[Docket No. RM13-11-000]

Frequency Response and Frequency Bias Setting Reliability Standard

ACTION: Notice of proposed rulemaking.

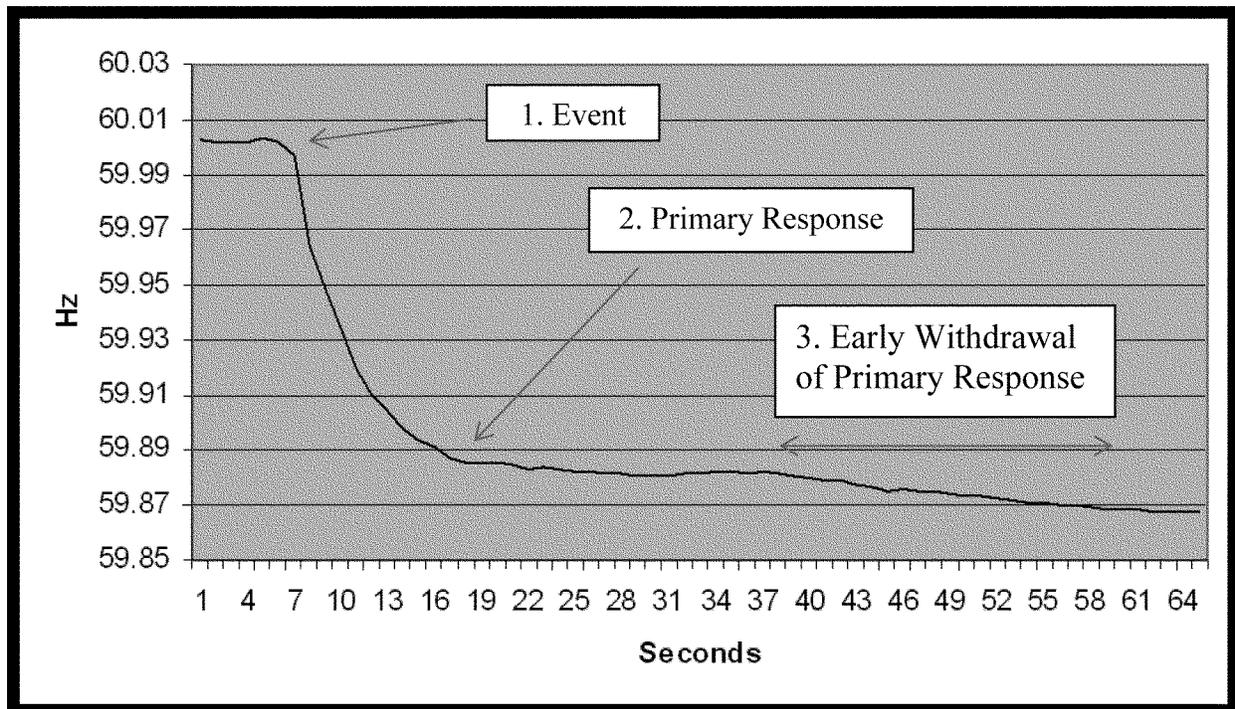
35. As explained above, following the sudden loss of generation, the automatic and immediate increase in power output by resources providing primary frequency control seeks to quickly arrest and stabilize the frequency of the interconnection, usually within 30 seconds or less. After this rapid primary frequency response, AGC provides secondary frequency response to return frequency to the scheduled value in time frames of several minutes after the loss of generation. If a significant amount of primary frequency response is withdrawn before the secondary frequency response is activated, a further drop in frequency response will occur. This drop in frequency is illustrated by the following diagram:⁵³

36. NERC indicates that, while the standards drafting team addressed the early withdrawal of primary frequency response, there are no requirements that address this issue and it remains a concern.⁵⁴ Specifically, during the initial recovery from the loss of a generator, a “gap” can occur if significant amounts of primary frequency responses are withdrawn before the secondary response is fully activated. As previously noted, the Interconnection Frequency Response Obligation for each Interconnection is a function of the resource contingency criteria and the maximum change in frequency.⁵⁵ The Frequency Response Initiative Report recommends that an adjustment should be made to the maximum allowable change in frequency to compensate for the predominate withdrawal of primary frequency response exhibited in an Interconnection until such withdrawal is no longer exhibited.⁵⁶ NERC includes an adjustment to provide an additional

38. We are concerned that proposed Reliability Standard BAL-003-1 does not adequately address the reliability issue associated with the withdrawal of primary frequency response prior to activation of secondary frequency response. The premature withdrawal of primary frequency response absent activation of resources providing secondary frequency response may lead to under-frequency load shed and possible cascading outages. Accordingly, we propose to direct that NERC develop a modification to BAL-003-1 to address the concern of premature withdrawal of frequency response prior to the activation of secondary frequency response.
